### **O-1 Latham & Watkins on behalf of Golden Door Properties LLC**

**O-1-1** The comment states the letter is submitted on behalf of Golden Door Properties LLC. The comment states that the Draft Environmental Impact Report (EIR) “does not cover all of the issues the County must consider and analyze”; that it is “missing crucial data, analysis, and mitigation measures”; and that it is not a “good faith attempt to analyze potential impacts on the surrounding community.” The County of San Diego (County) does not concur with this comment. The County acknowledges the comment as an introduction to comments that follow, and notes that it expresses the opinions of the commentator. The comment does not raise any issue related to the adequacy of any specific section or analysis of the EIR; accordingly, no specific response can be provided or is required. The County will include the comment as part of the Final EIR for review and consideration by the decision-makers prior to a final decision on the Newland Sierra Project (project). No further response is required or necessary.

FIGURE 2-2

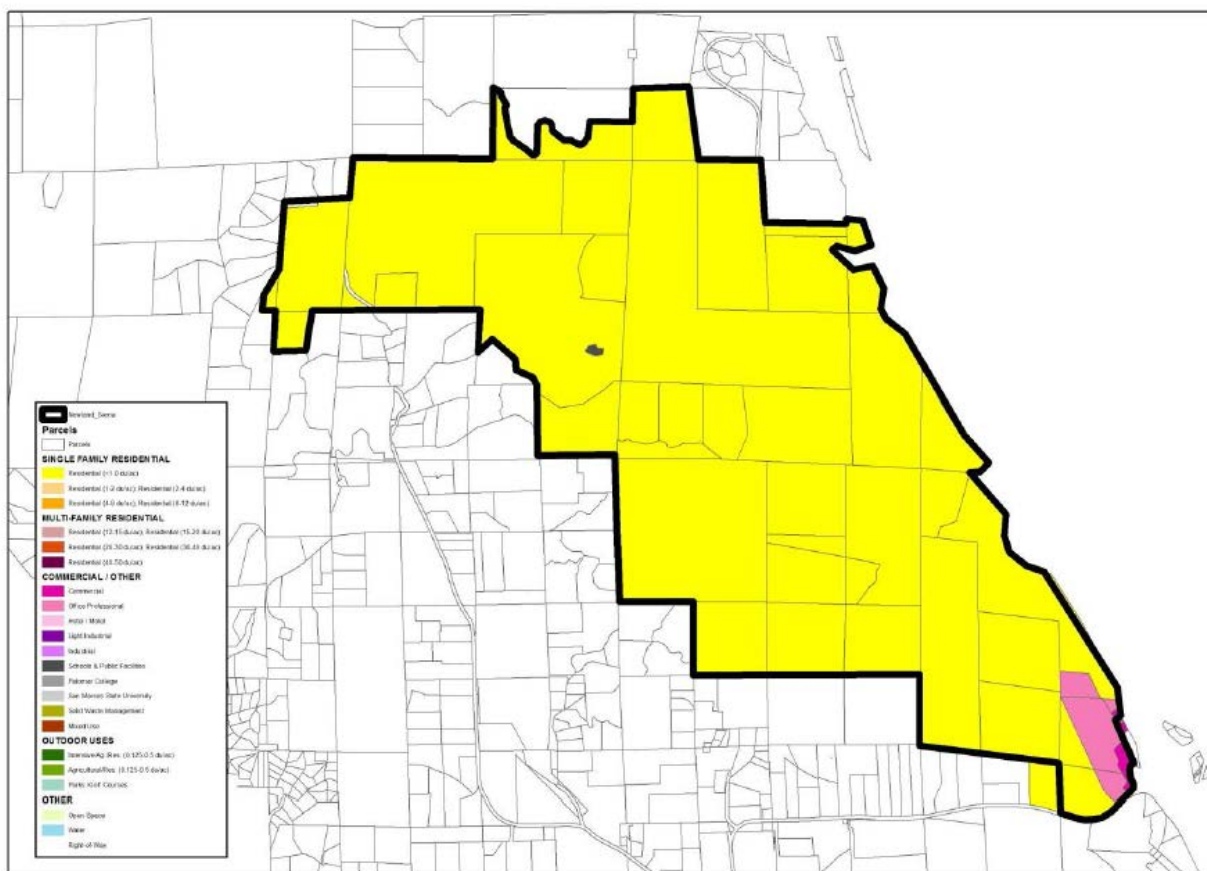
The project's WSA, which is found in Appendix S to the Draft EIR, included its own appendix (Appendix B), which is VWD's draft "2014 Master Plan, Water and Wastewater Duty Factors." This draft: (1) explained the status of the 2014 Master Plan process and schedule; (2) assigned approved land use information from all land use agencies served by VWD, including the County; (3) obtained updated data from SANDAG; (4) assigned water duty factors to various land use categories; (5) compared those factors to, among other things, previous VWD master plans; (6) identified projected versus actual water demands by land use category; and (7) found "very few changes" between the 2008 Master Plan water duty factors and the recommended 2014 draft Master Plan water duty factors. In short, VWD's 2014 draft Master Plan data was available, understandable, and the 2014 water duty factors as a whole (i.e., considering all land uses together) are similar to VWD's previously adopted 2008 water duty factors.<sup>80</sup>

The WSA also explained that VWD's revised water demand factors used to develop the Newland Sierra demand projections were "documented in the District's Draft 2014 Water, Wastewater, and Recycled Water Master Plan" and that "the District's unit water demand factors were presented to the District Board in a public workshop on July 5, 2016 and approved on September 21, 2016," with the "workshop presentation included in Appendix B" to the WSA (Draft EIR, Appendix S [WSA], page 44).

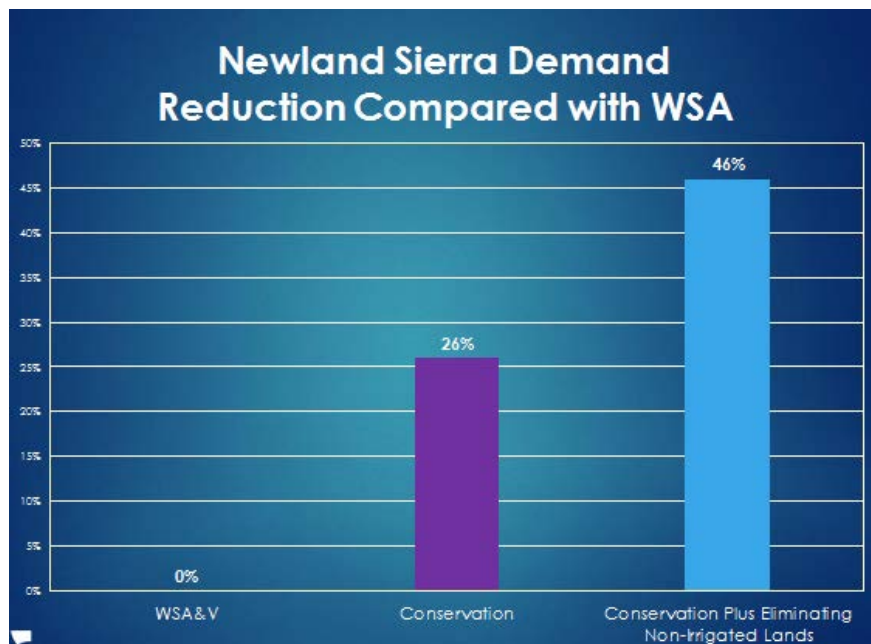
In the GSI study, total project water demand reductions achieved by implementing current (2015/2016) water conservation standards are compared to the WSA. In summary, compared with the WSA's project water demand estimate of 1,450,160 gallons per day ([gpd] or 1,624 afy), the following would occur:

- With imposition of the current (2015/2016) water conservation regulatory requirements, the project's water demand will be reduced by 26 percent (when compared to the WSA's water demand estimate).
- By implementing these required water conservation measures, the project's total water demand would be reduced to 1,068,220 gpd (or 1,196 afy) through water conservation alone.

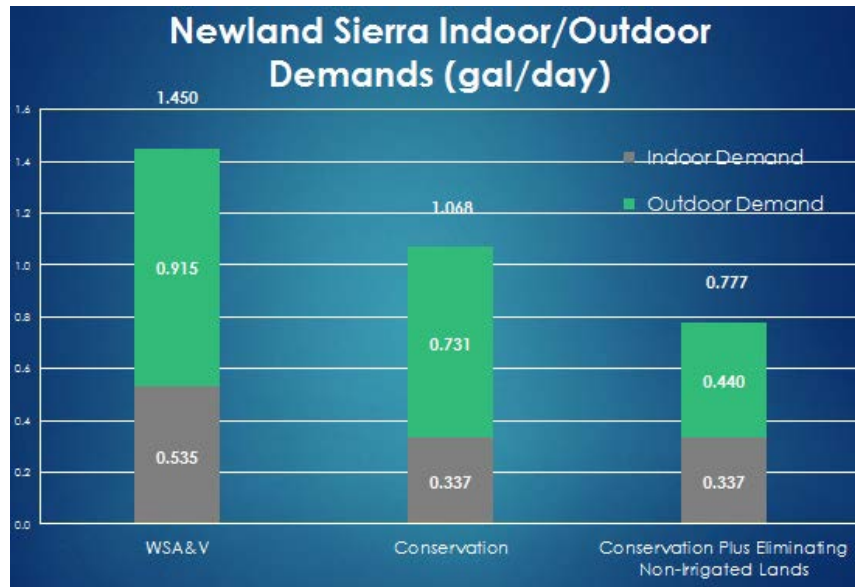
By additionally eliminating irrigation in the open space and non-irrigated fuel management zones, the blue bar shows that the project can achieve a 46 percent reduction in water demand when compared to the WSA.

### **Total Project Water Demand Reductions (i.e., Water Savings) Compared with General Plan**

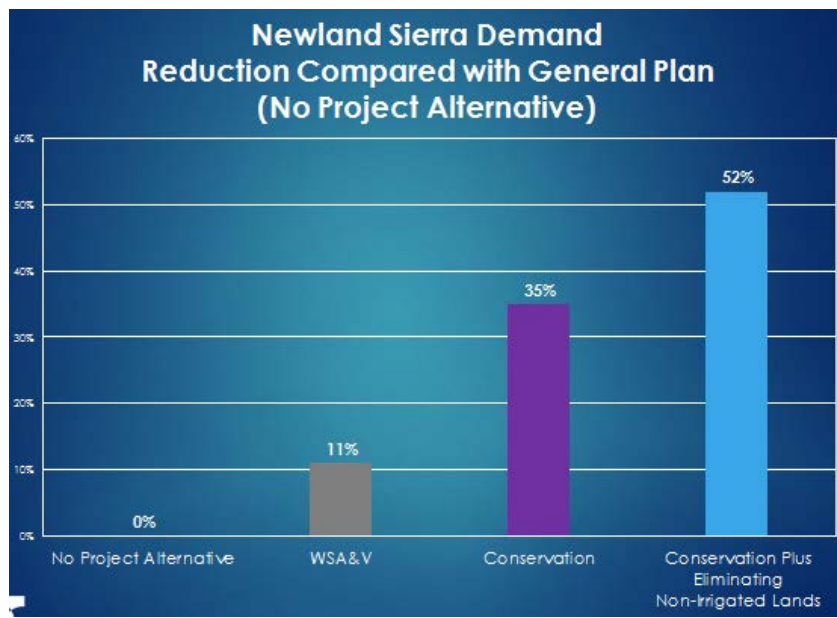
The GSI study also evaluated the project's total water demand reductions (arising from 2015/2016 water conservation standards) and compared those reductions to the County's 2011 General Plan land use/zoning-based projected water demands (which do not account for these more current conservation standards) (see Draft EIR, Appendix T [GSI Study], pages 1 and 18 through 19). Total project water demand reductions by percentage compared with the General Plan are shown below.

As reflected in the WSA, the brown bar shows that the project's water demand will be 11 percent lower than the water demand already projected for this same project area based on the County's General Plan.

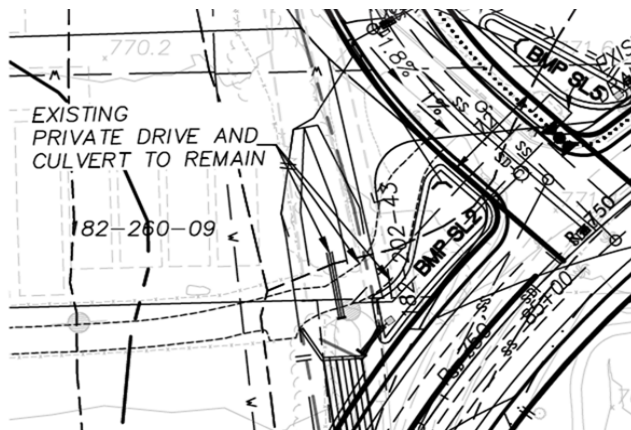
- O-1.12-6** The comment notes Deer Springs Road varies in width where walls are proposed which eliminates the possibility of an intermittent center left turn lane or auxiliary curb lane. The comment notes this conflicts with the Draft EIR, Section 1.0 Project Description, page 1-11. Under Option B, the section of Deer Springs Road where retaining walls would be required would have a reduced median and a reduced Right-of-Way to reduce environmental impacts and this section of the road would not allow for an intermittent turn lane, however, the balance of the road would have a standard median to allow for intermittent turn lanes. The description of Option B on page 1-11 has been revised in the Final EIR from “4.1B Major Road (four lanes of travel with continuous left turn lane)” to match sheet 16 of the Preliminary Grading Plan which correctly describes the roadway as a “4.1B Major Road with Intermittent Turn lanes.”

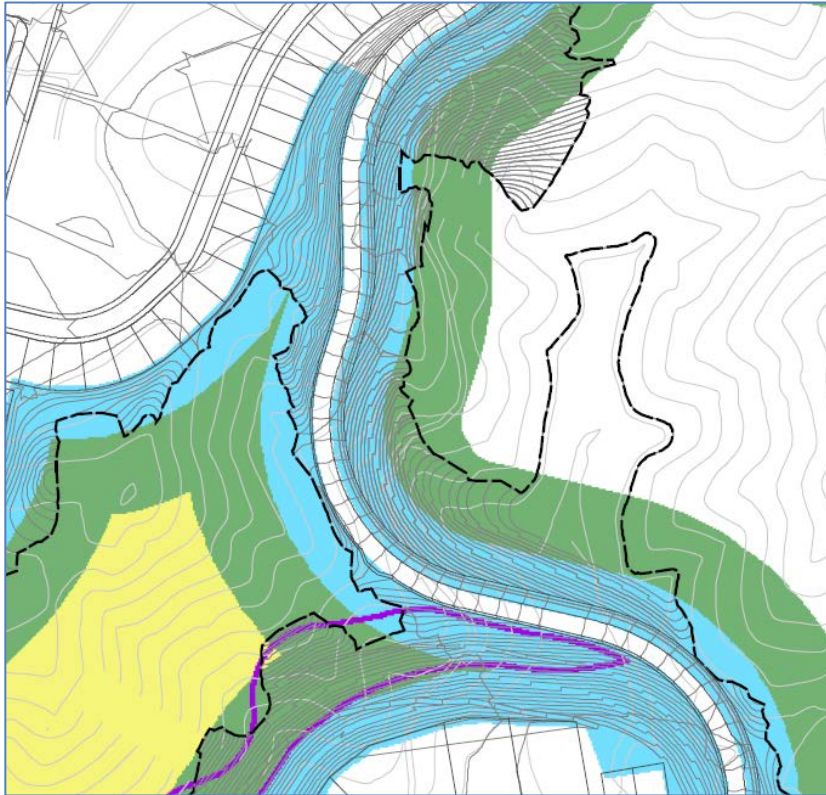
**O-1.13-11** The comment incorrectly states that some of the Proposed Project's exits are lined by fuel and could be blocked during a wildfire. It further suggests with an aerial image of Gist Road that residents would be required to evacuate through the pictured wildland fuels that could be burning, creating a dangerous evacuation scenario.

The County agrees that a major concern during an evacuation is the potential for exits to be blocked by a wildfire; however, the County disagrees with the commentator that this would be the case at the Project site. The commentator relies on current, undeveloped conditions to draw an unsubstantiated conclusion. The Proposed Project's Fire Protection Plan (Sections 2 through 6) includes a comprehensive terrain, fuel, and fire weather analysis and based on that analysis, required site-wide and roadside fuel modification zones that are 5 to 12.5 times as wide as the standard, code-required 20 foot zones.
